TECHNICAL AND SERVICE BULLETIN

NO: 36

TO: ALL KOMPAC DEALERS
SUBJECT: SEAL BURN IN

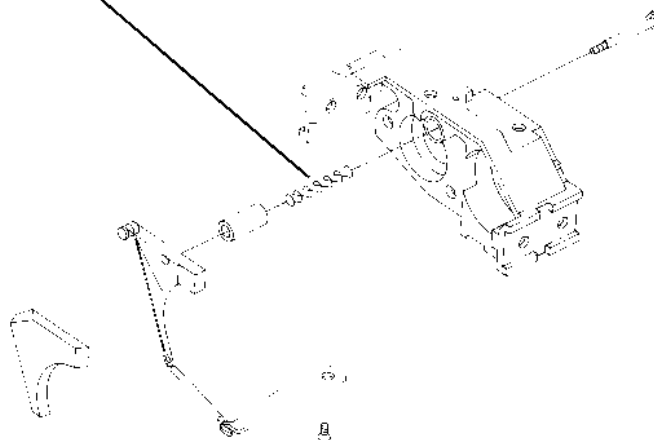
We have attributed these problems to lightweight backing plate springs which were used to compensate for the old style graphite-impregnated seals and also dirt build-up.

Apparently some of these lightweight spring continue to be used and actually are not compatible with the current seals in use. This, along with dirt build-up, has a weakening effect and, therefore, does not exert enough pressure to properly burn in the seals.

The lightweight springs may be identified by their silver color as opposed to the heavy, bronze colored springs.

If seals not seating properly is a continuing problem, please call Graph Tech Customer Service (1-800-541-5702) for replacement springs, free of charge. Labor, however, will not be credited.

92238

Compression Spring
